ADDENDUM #2

NORTH TRUCKEE DRAIN REALIGNMENT PHASE 1

BID #13/14-007 – PWP# WA-2014-011

This addendum is to notify all potential proposers of clarifications made to the Bid documents as stated below.

DOWEL BAR DIA. d IN. MIN.	TIE BAR SIZE REBAR t	LENGTH OF TIE BAR L IN.
1-1/2"	No. 5	30

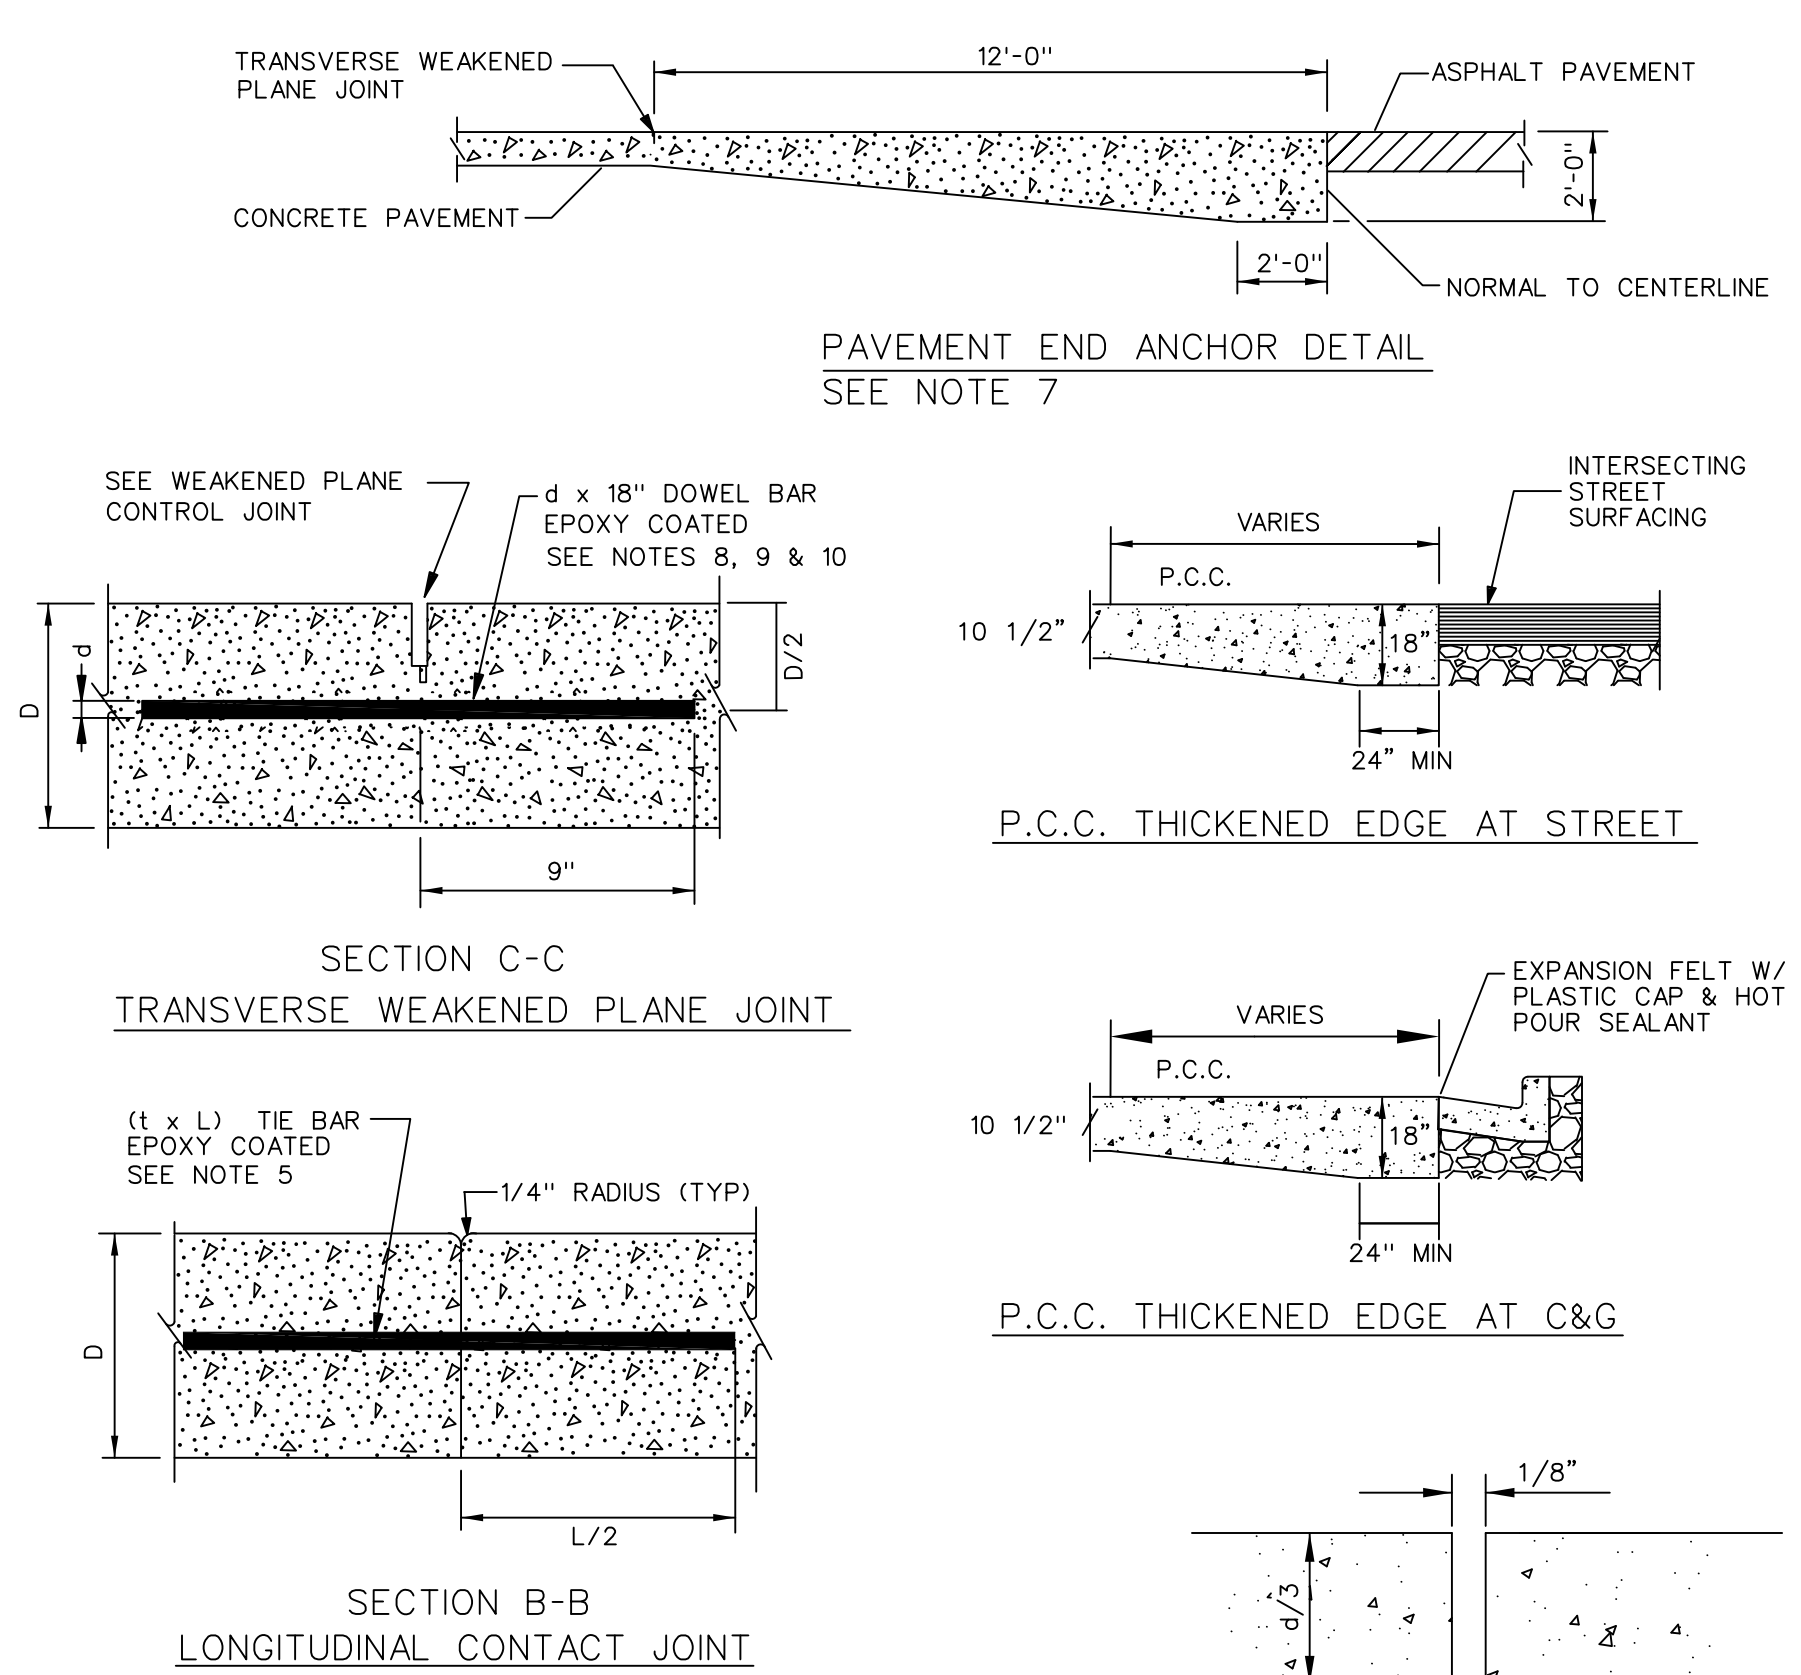
18. Sheet DT-6 – The Portland Cement Concrete details (top half of the sheet) were all removed and replaced.
19. Sheet DT-7 – The lower middle detail titled "Loop Detector Notes, Layout and Details" was added.
